UNITED STATES PATENT AND TRADEMARK OFFICE

APPLICATION NO.	FILING DATE	FIRST NAMED INVENTOR	ATTORNEY DOCKET NO.	CONFIRMATION NO.
10/576,610	04/21/2006	Toshio Yamauchi	0969-0187PUS1	2059
2292	7590	10/27/2009	EXAMINER	
BIRCH STEWART KOLASCH & BIRCH PO BOX 747 FALLS CHURCH, VA 22040-0747				MORGAN, EMILY M
ART UNIT		PAPER NUMBER		
3677				
			NOTIFICATION DATE	DELIVERY MODE
			10/27/2009	ELECTRONIC

Office Action Summary	Application No.	Applicant(s)	
	10/576,610	YAMAUCHI, TOSHIO	
	Examiner	Art Unit	
	EMILY M. MORGAN	3677

DETAILED ACTION

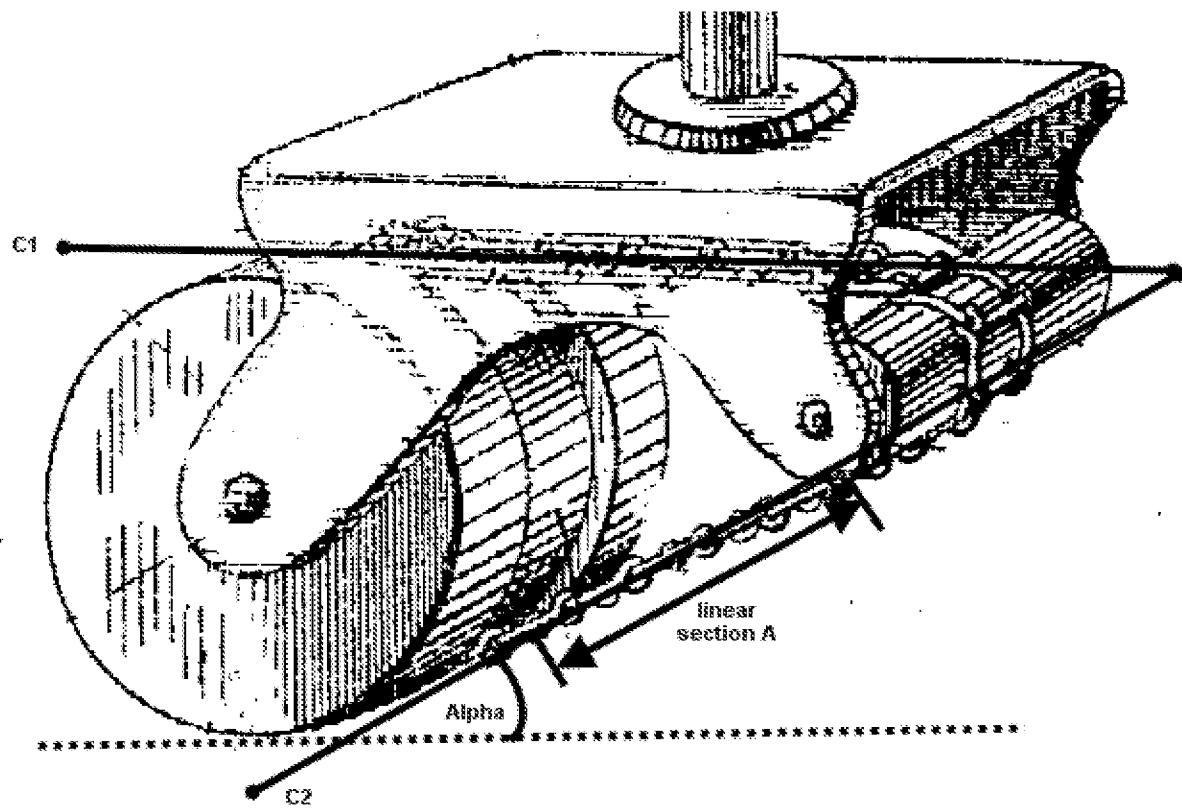
Regarding claim 1, Rison discloses a caster (figure, shown below) comprising: first 19 and second 21 wheels attached to a mounting leg 11; at least one of the first 19 and second 21 wheels is pivotably attached to the mounting leg (both are pivoting around the wheel's axis); the first 19 and second 21 wheels disposed forward and back and an endless wrap-around member 22 wrapped around the first 19 and second 21 wheels, the first and second wheels having common tangents C1 and C2, the common tangent C2 having an angle (alpha) with respect to a ground surface, wherein the

wraparound member 22 is a continuous endless belt formed by connecting a plurality of pieces (links, line 56) via a plurality of connecting members, the wraparound member having a linear portion A formed along at least the common tangent C2 of the wheels (all shown below). Rison does not disclose the specified structure of the wraparound member.

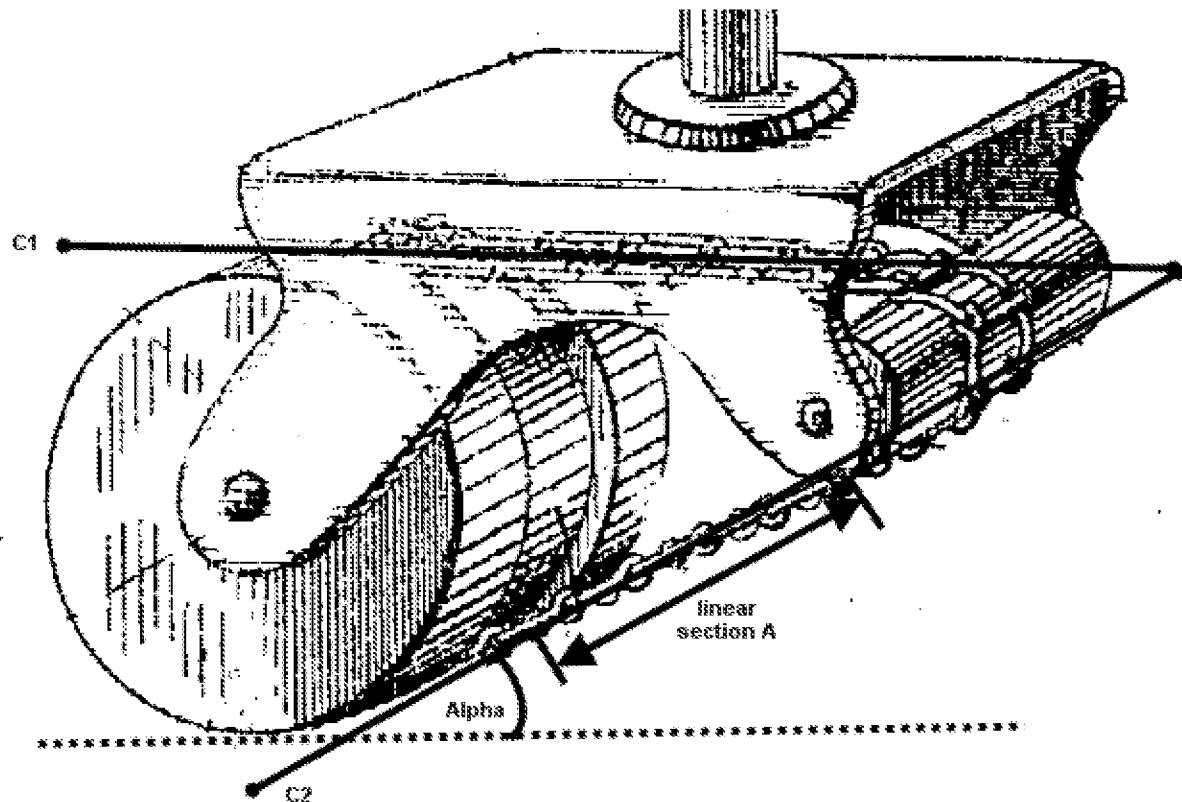
Since the contacting sections of the adjacent pieces abut respectively against each other along a linear portion (shown in figure 2), when the pieces are applied to the Rison caster, the effect would be the same along the linear portion of tangent C2. The Barnard applied tread along the linear portion A of the common tangent C2 is capable maintaining a linear condition and is prevented from being dented, so that even when the linear portion A is pushed by a force from an outside, the linear portion A is capable of serving as an anti-sticking plate. This is done because the pressure faces are adapted in Barnard to prevent reverse bending of the track member (column 1, line 43).
